URGENT - FIELD SAFETY NOTICE

**MAQUET VOLISTA
Field Action MSA/2017/006/IU**

Product Issue: Detachment of the central handle holder from the VOLISTA surgical light

Field Safety Notice: MSA/2017/006/IU

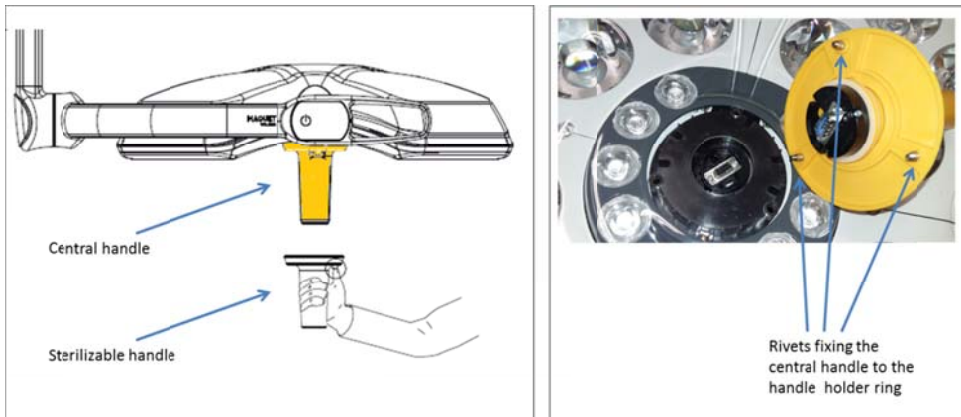
We received complaints indicating that the central handle holder detaches easily from the cupola during use. We determined that the root cause of this malfunction is excessive tightening of the screws during mounting of the handle holder, resulting in the rivets loosening and detaching from the central handle holder ring.

During manipulation, the handle holder may completely detach from the light head, if all three rivets loosen simultaneously. In this case, although the handle remains in the user's hand, small quantities of particles may be generated from the plastic holder ring. From our clinical evaluation, it was concluded that there is a remote chance that this issue may cause post-operative infection, foreign body granuloma or allergic reactions, if the particles fall into the patient's wound or on sterile equipment.

The issue was solved in production by a design change of the rivets (modification of shape and overmolding with the handle holder ring). For units manufactured before application of the modification in production, we see the issue as a potential long term hazard and want to prevent any related event from occurring with our customers. This action consists in the replacement of the existing central holder rings with the new design.

Resolution: Maquet proposes to replace the central holder ring of your VOLISTA surgical light to make sure all devices present in the market are working effectively and safely.

This letter is to inform you of a corrective action that will be performed on these units to prevent a possible hazard to persons and equipment. This action consists in a the replacement of the central handle holder ring.
